Version C Villa Door Stations Release Note

(2025-09-10)

Firmware Basic Information	Firmware Version	V3.7.0_build250905
	Device Model	DS-KV8X13-WME1(C) DS-KV6113-WPE1(C), DS-KV6113-PE1(C), DS-KV6103-PE1(C) DS-KV6133-ME1, DS-KV6133-WME1 DS-KIS603-P(C), DS-KIS604-P(C), DS-KIS604-S(C)

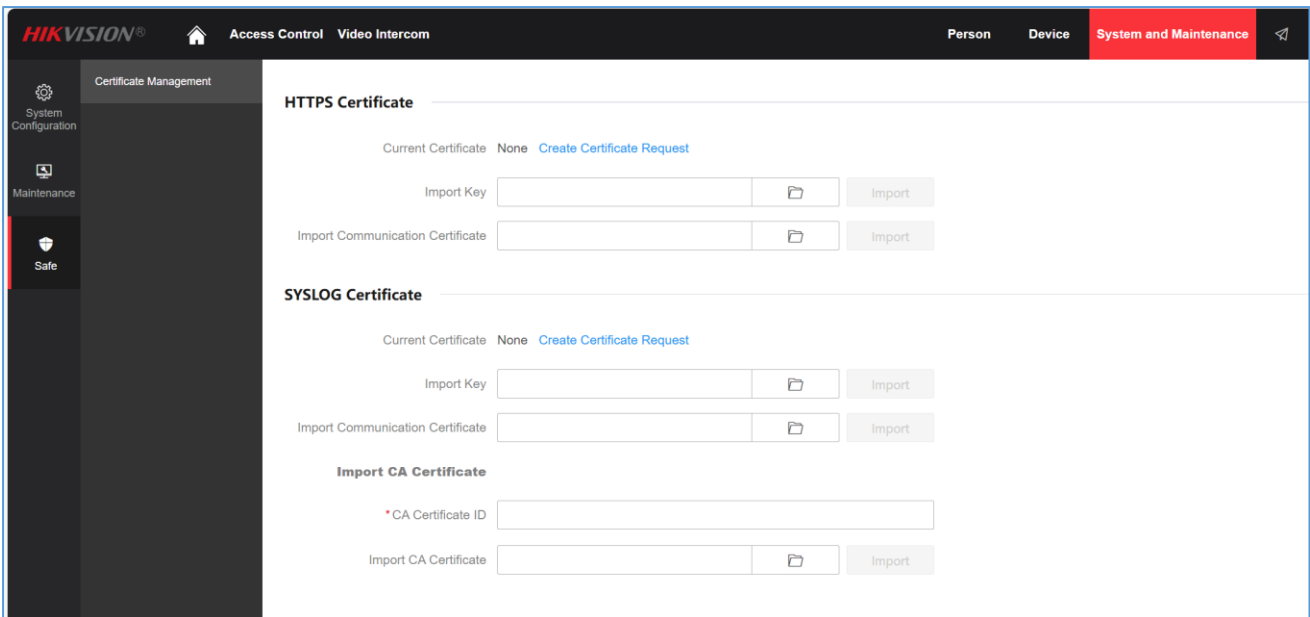
9. Support protocol testing, security audit log uploading, https certificate import, device debugging for easier integration and higher security.

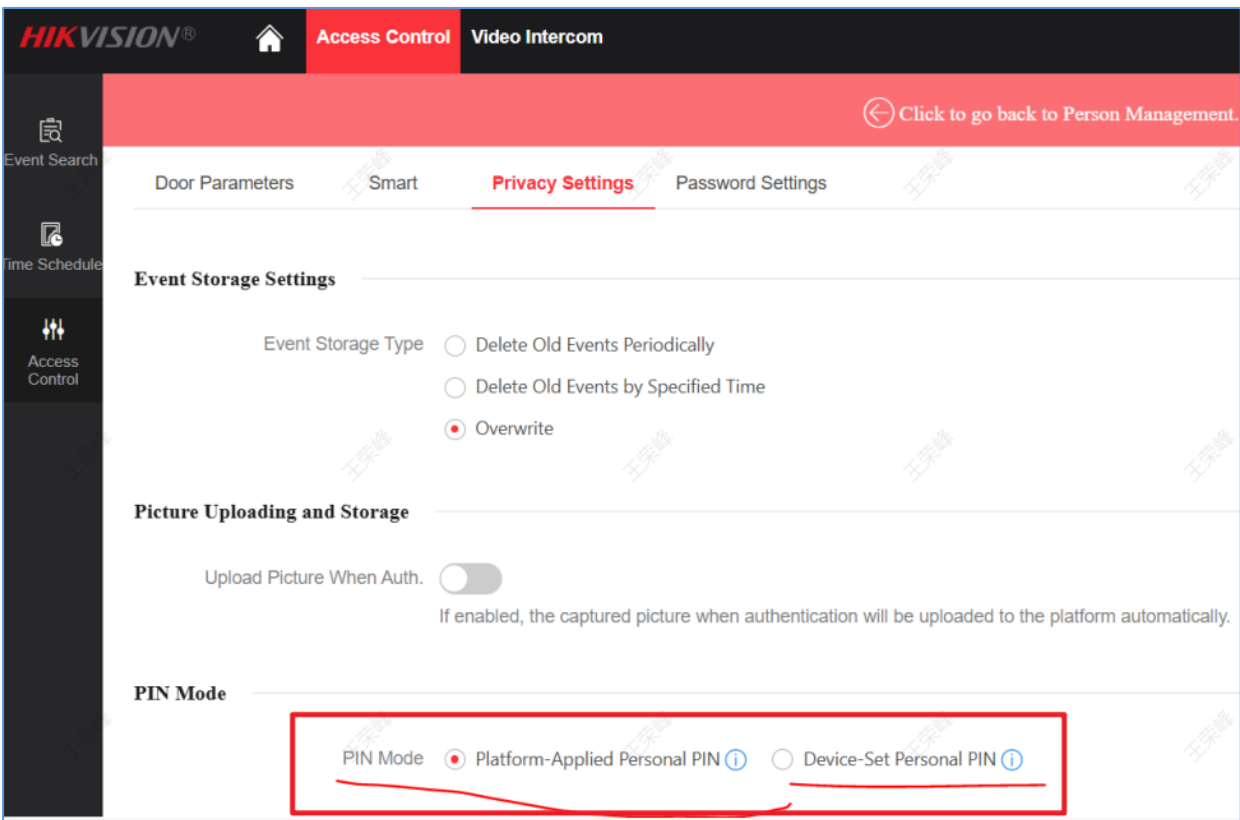
When adding person & PIN from indoor station (V2.2.100_250114) local screen and sync to door station, please make sure the PIN mode in door station webpage is **Platform-Applied Personal PIN**, or the PIN will not work on door station side.

And we will optimize from indoor station firmware in future version, after that, we don't need to change mode from door station.

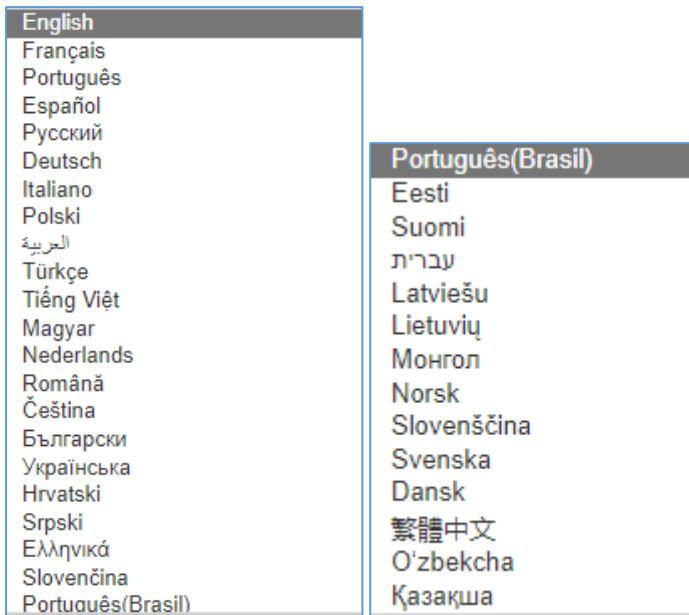
1. Add Account Security Settings function, you can reset the password with security question or your email address.

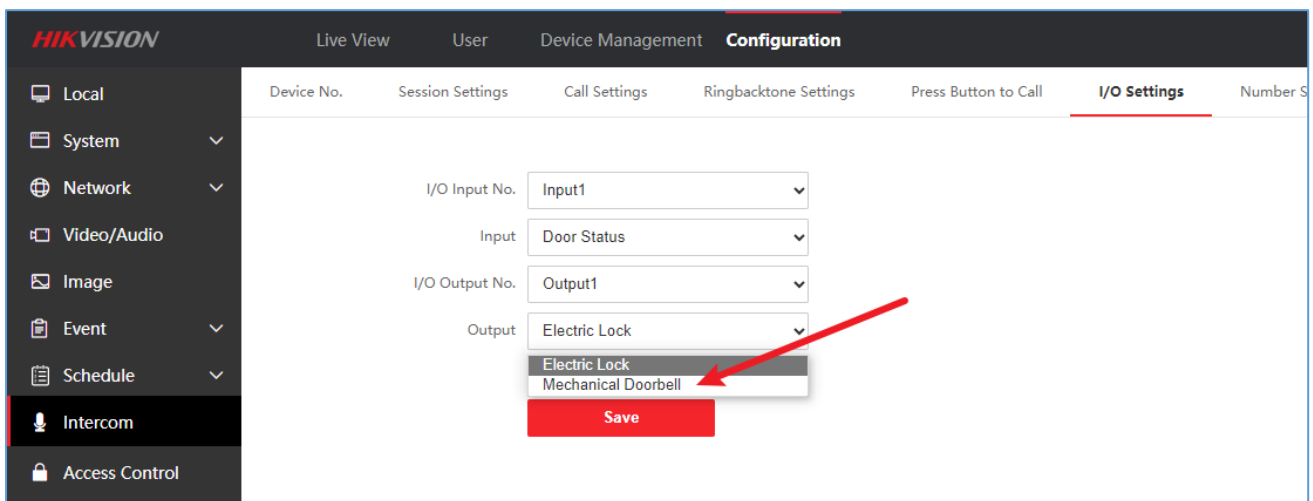
2. Add 13 new languages, now in total support 35 languages. Only two voices "door is open" and "please leave a message" are retained, and the rest of the prompt tones are replaced by Didi, busy tones, etc
